FORM APPROVED  
OMB NO. 1004-0137  
Expires: January 31, 2018**SUNDRY NOTICES AND REPORTS ON WELLS**  
**Do not use this form for proposals to drill or to re-enter an abandoned well. Use form 3160-3 (APD) for such proposals.****SUBMIT IN TRIPLICATE - Other instructions on page 2**

Subarea : Avolon  
 Lease & Well No. : Buck Federal 20-6H  
 Legal Description : Sec-20C T-26S R-32E NE NW  
 County : Lea State : New Mexico  
 Field : JENNINGS (Red Hills West)  
 Date Spudded : 2/16/2013  
 API Number : 30-025-40902

Permanent Abandonment of Federal Wells  
Conditions of Approval

**WELLBORE SKETCH**  
**ConocoPhillips Company - Permian Basin Business Unit**

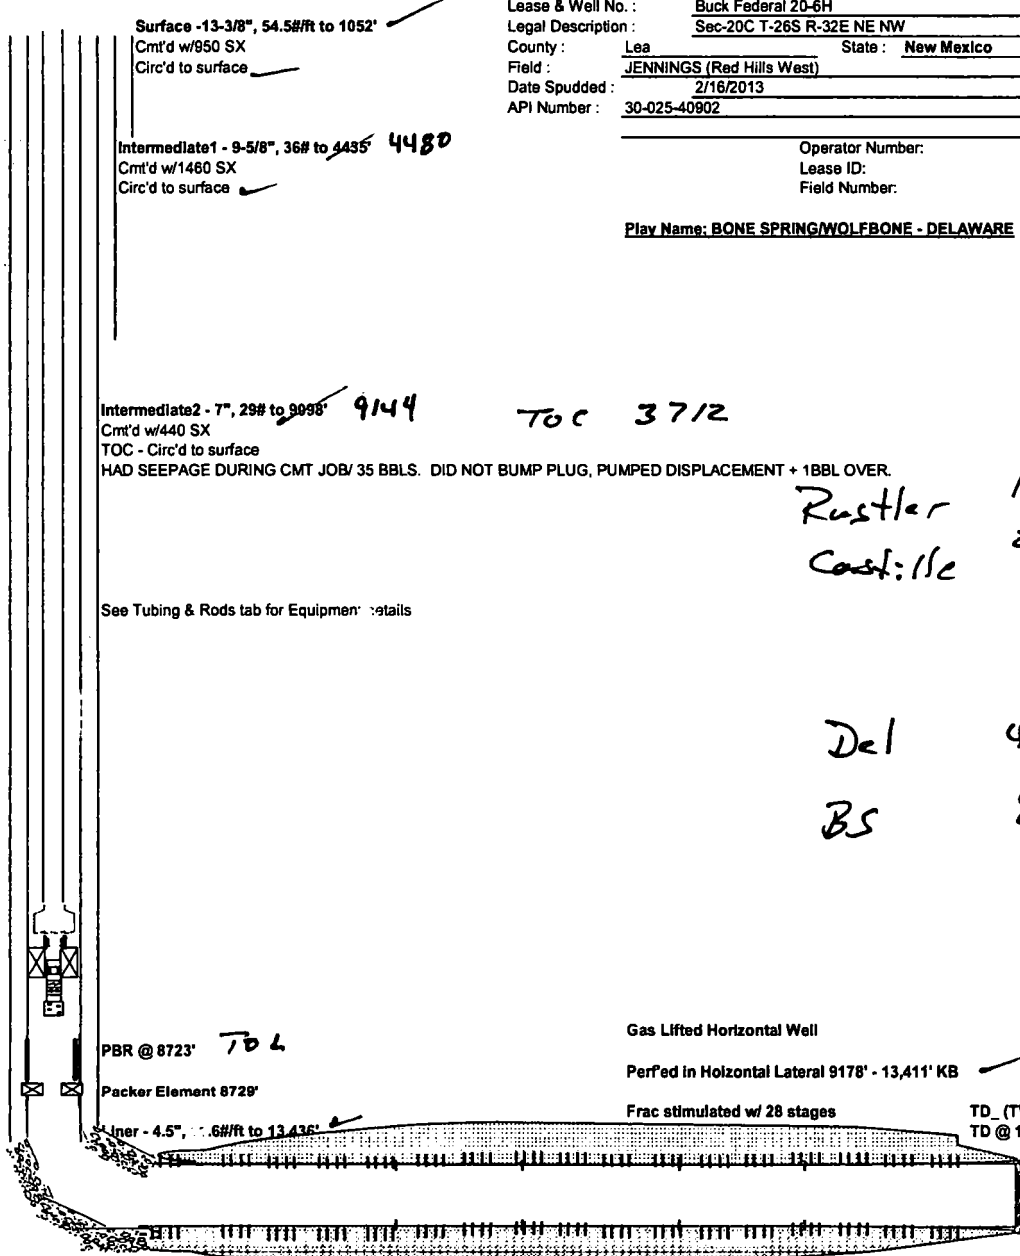
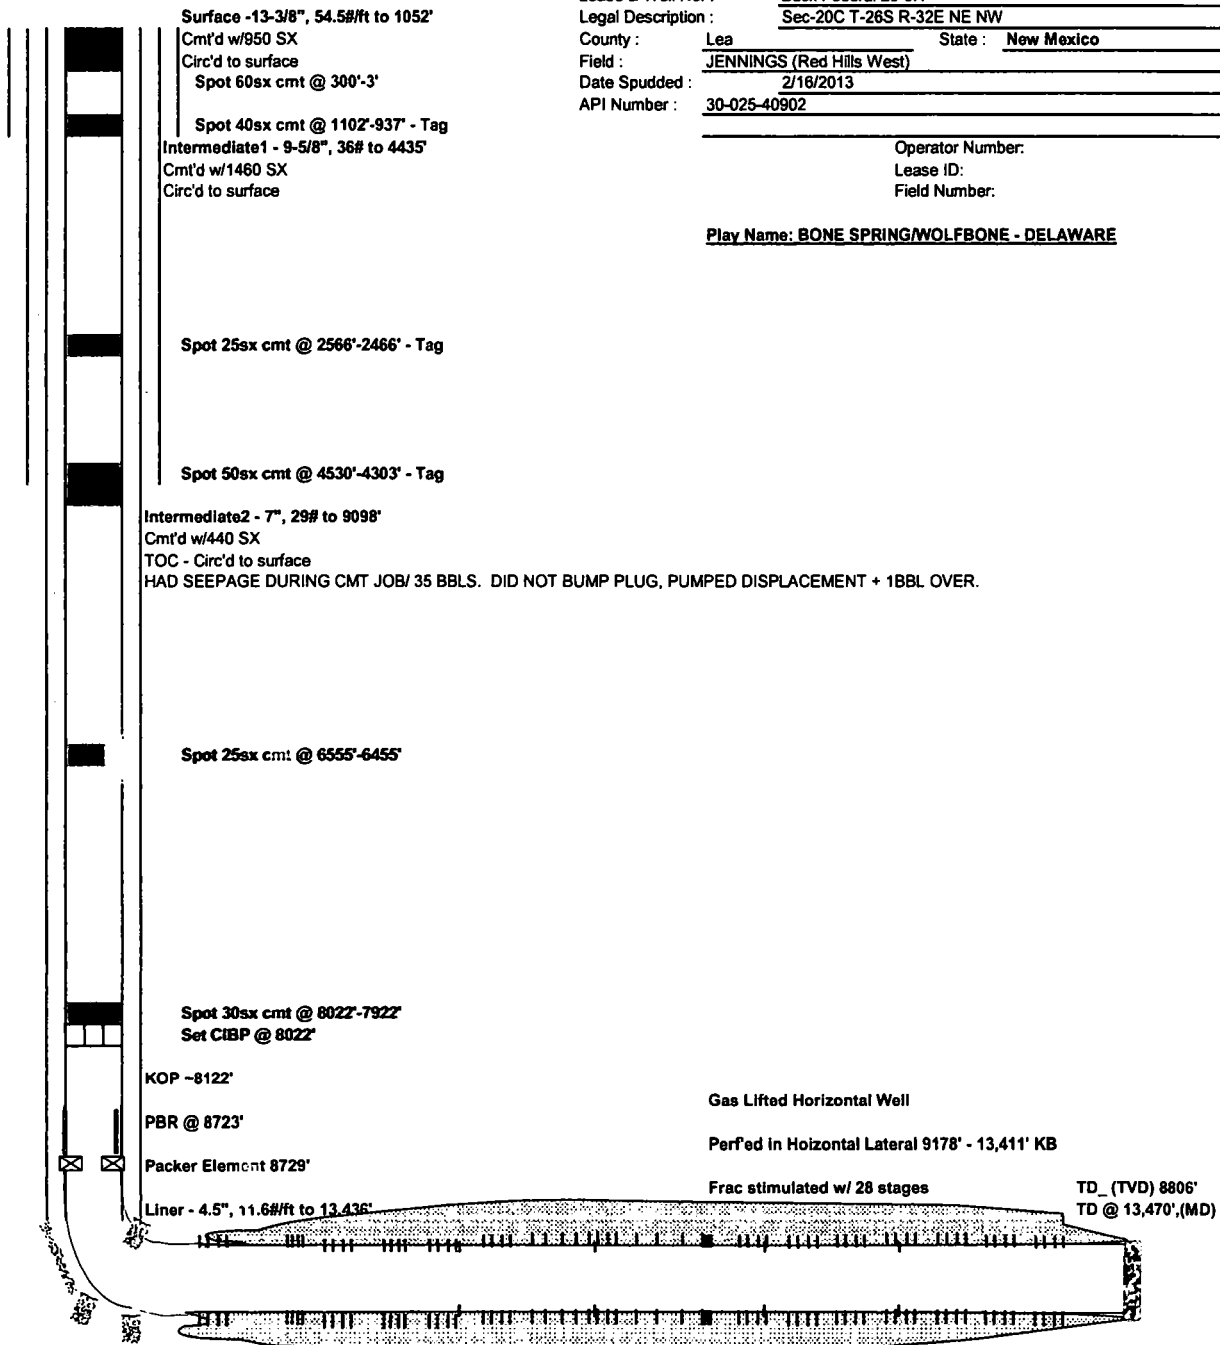
- 1) MIRU. NU WH, ND BOP, POOH w/ Prod Equip
- 2) Set 7" CIBP @ 8022' Circ hole w/ MLF. Pressure test casing 8700 - 8510 cmt.
- 3) Spot 30sx cmt @ 8022' - 7922' 8237 - 8057 (T/B)
- 4) Spot 25sx cmt @ 6555' - 6455' 6395 (SPACER)
- 5) Spot 50sx cmt @ 4530' - 4303' WOC-Tag
- 6) Spot 25sx cmt @ 2566' - 2466' WOC-Tag 2446
- 7) Spot 40sx cmt @ 1102' - 937' WOC-Tag
- 8) Spot 60sx cmt @ 300' - 3' Verify
- 9) RDMO. Cut off WH & anchors, install DH marker.

**SEE ATTACHED FOR  
CONDITIONS OF APPROVAL***Below ground level dry hole marker required*

Intermediate1 - 9-5/8", 36# to 4435' **4480**  
 Cmt'd w/1460 SX  
 Circ'd to surface ✓

Intermediate2 - 7", 29# to 9098' **9144** **TOC 3712**  
 Cmt'd w/440 SX  
 TOC - Circ'd to surface  
 HAD SEEPAGE DURING CMT JOB/ 35 BBLs. DID NOT BUMP PLUG, PUMPED DISPLACEMENT + 1BBL OVER.

**Rustler 1037**  
**Cost: 1/c 2566**

**Del 4378**  
**BS 8187**

**\*\* BLM REVISED \*\* BLM REVISED \*\* BLM REVISED \*\* BLM REVISED \*\* BLM REVISED \*\*****FOR RECORD ONLY***XZ NM OCD*
